PRE-HEARING
GROUND WATER DISCHARGE PLAN ANALYSIS

MT. TAYLOR URANIUM MILL PROJECT
GULF MINERAL RESOURCES COMPANY

Ground Water Section
Water Pollution Control Bureau
New Mexico Environmental Improvement Division

September, 1980

FIGURE 14

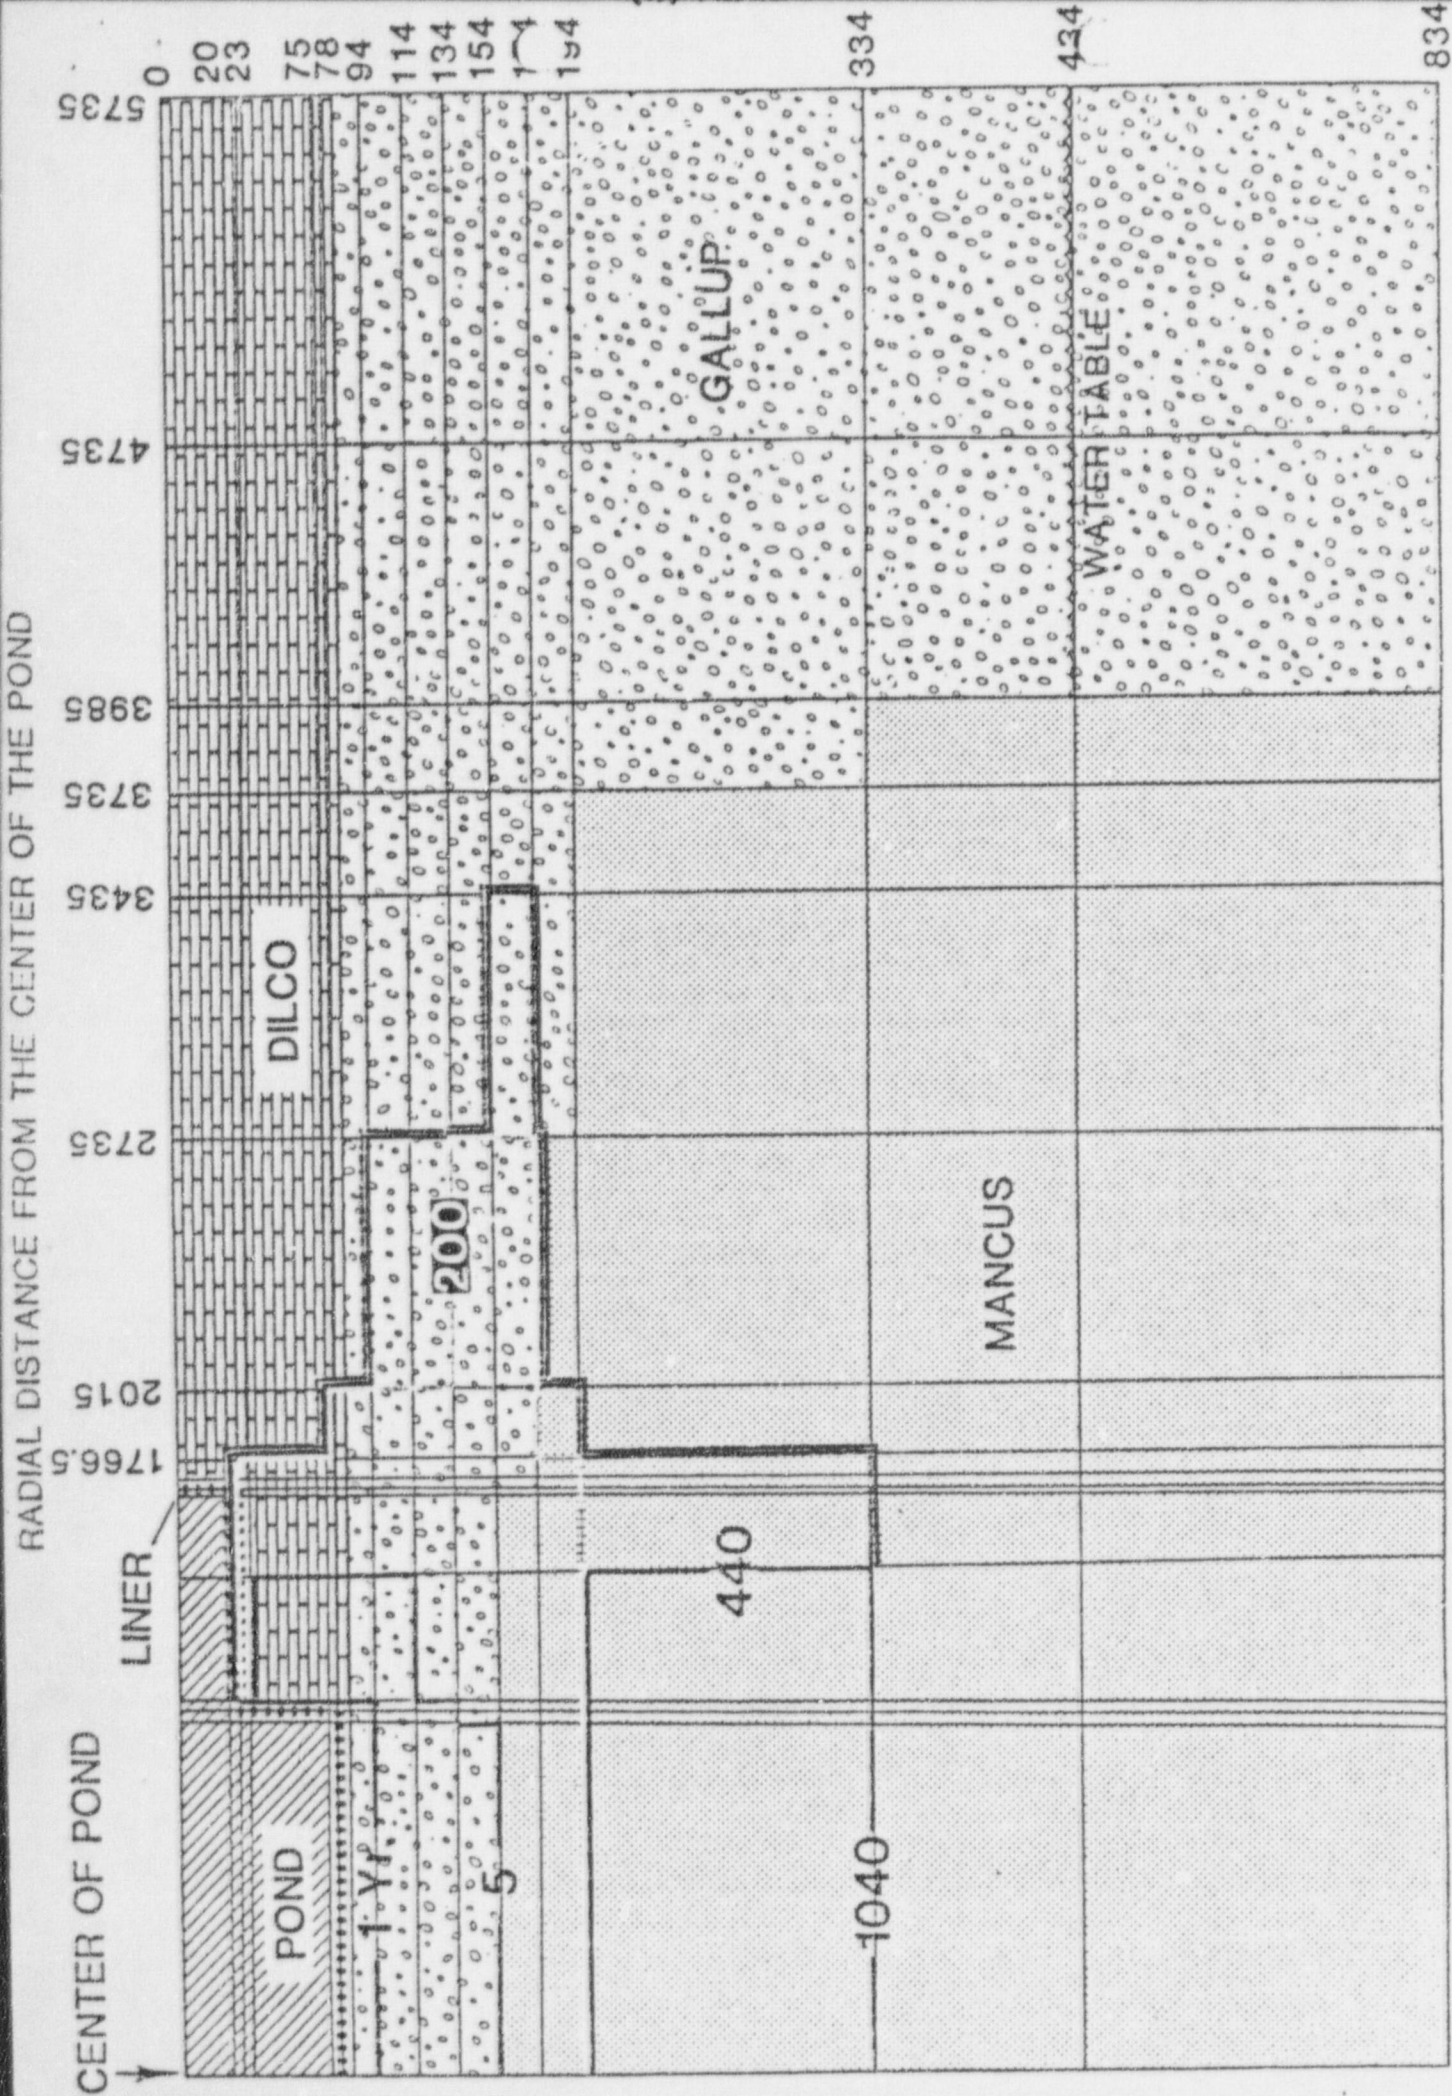
An additional computer simulation considered staff-suggested saturated and unsaturated hydraulic conductivity values. Table 3 shows the saturated hydraulic conductivities employed for this simulation. Adjustments in both horizontal and vertical hydraulic conductivities were made to consider probable vertical stratification in hydraulic conductivities and bedding plane induced anisotropy (horizontal hydraulic conductivity: vertical hydraulic conductivity = 20:1). Hydraulic conductivities of the liner were increased by a factor of 10. Figure 14 shows the results of the later simulation. The seepage front has not advanced as far as the front in the original work at a comparable time.

Based upon the information referenced above, the staff supports Gulf's conclusion that the seepage front will not invade the water table. This interpretation, of course, must be predicated upon proper quantification of the hydrologic properties of the site. Upon implementation of construction and monitoring activities, additional field data will become available for consideration. If site conditions are then found to be significantly different than present data suggests, the seepage projections should be revised.

FIGURE 15

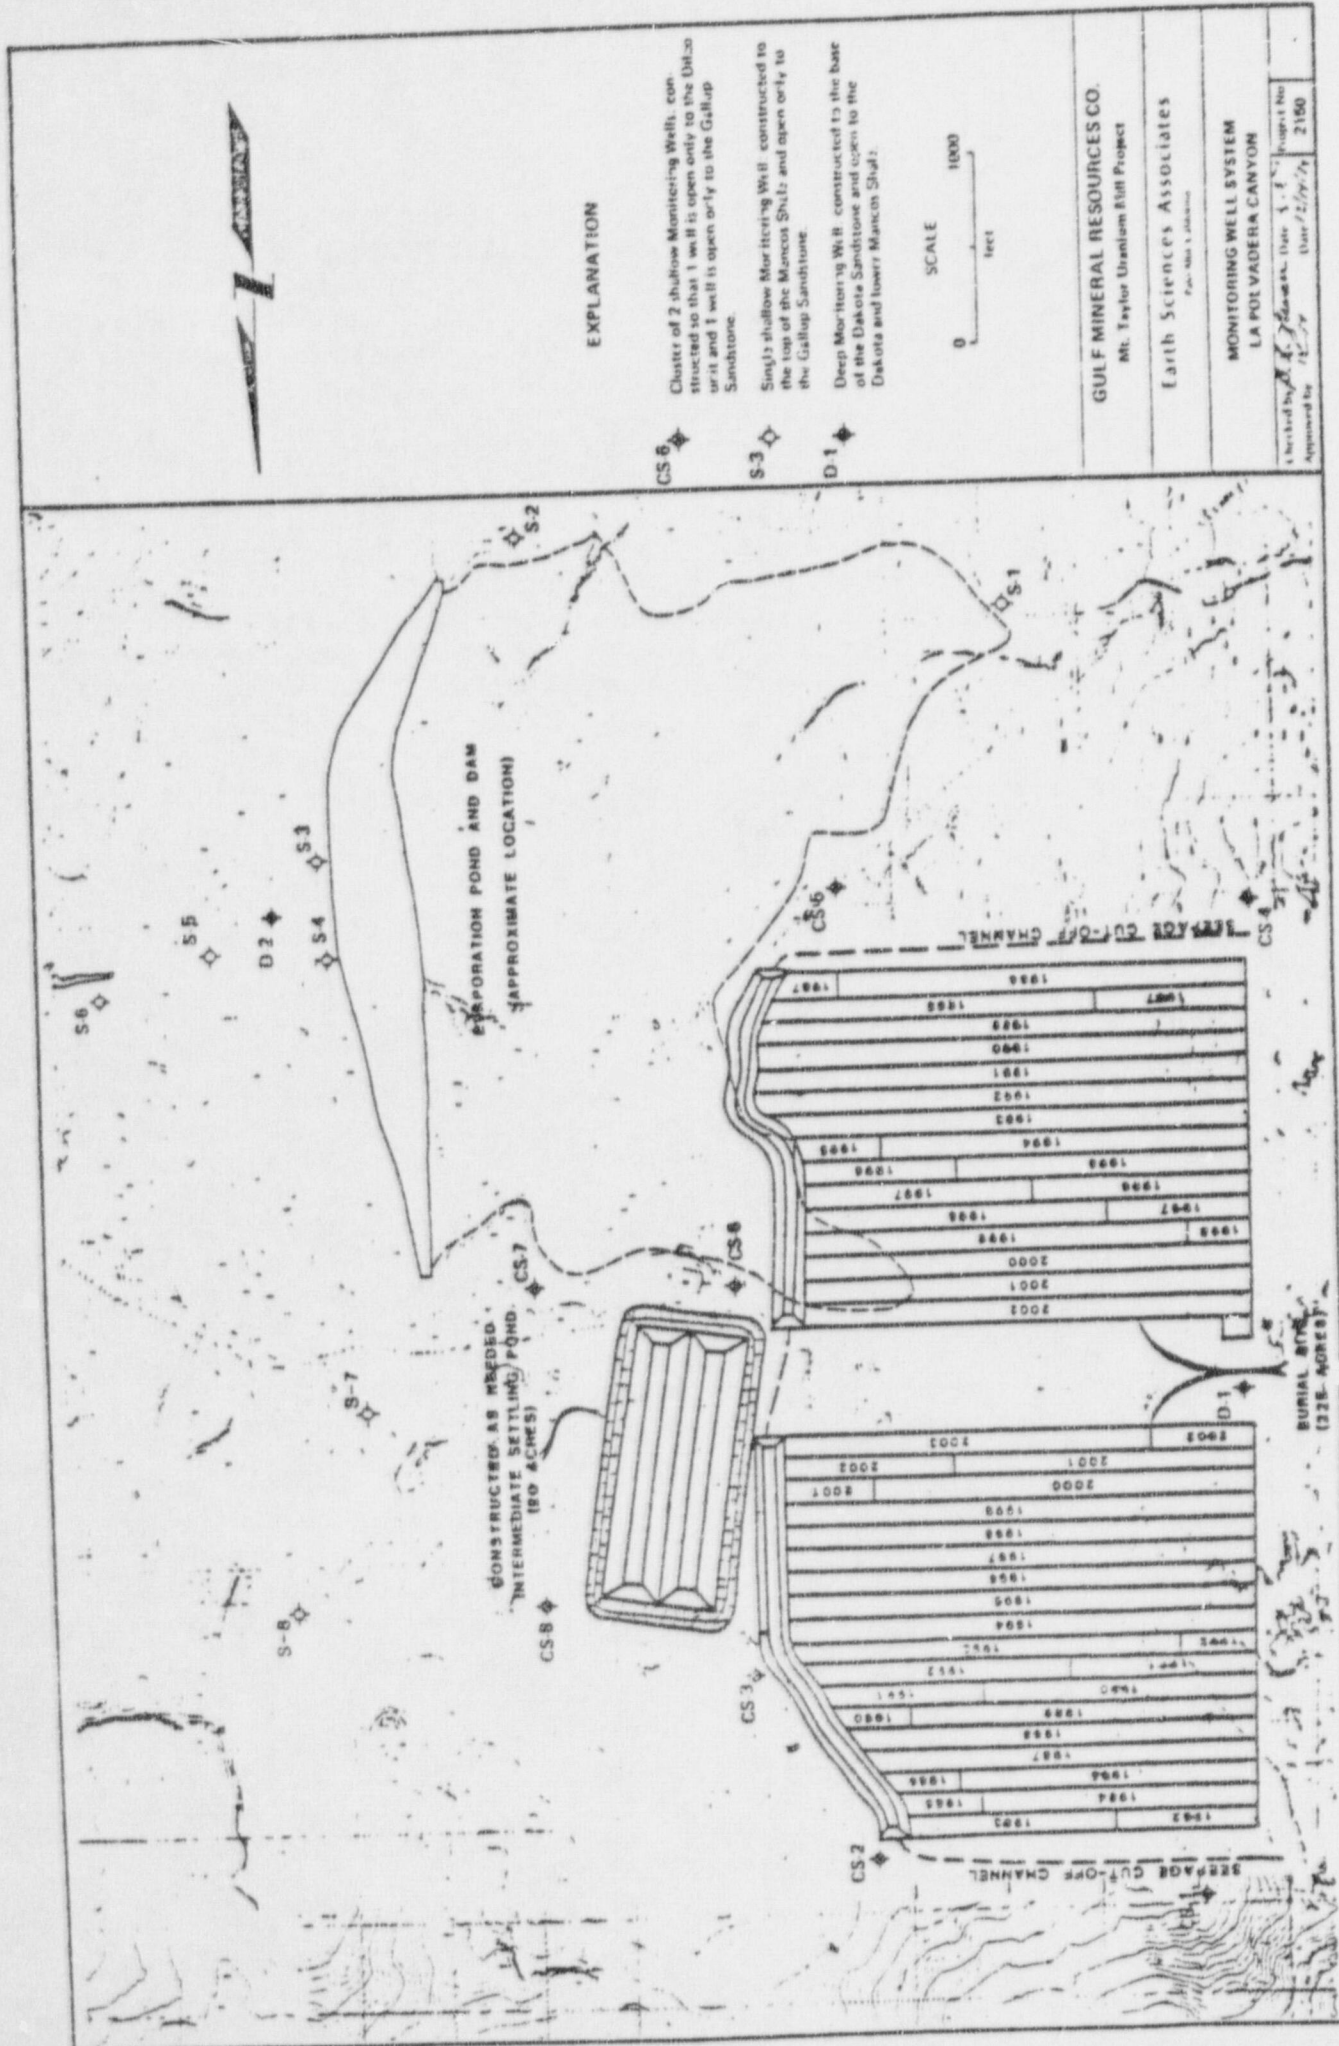
Given the uncertainties regarding rock conditions at the pond site, the staff does not feel that a final monitoring array can be established prior to pond-bottom exhumation. In general, the proposed shallow array shown in Figure 15 seems acceptable; it is considered prudent, however, to hold in abeyance recommendations regarding the monitoring configuration and design until this additional on-site data can be incorporated.
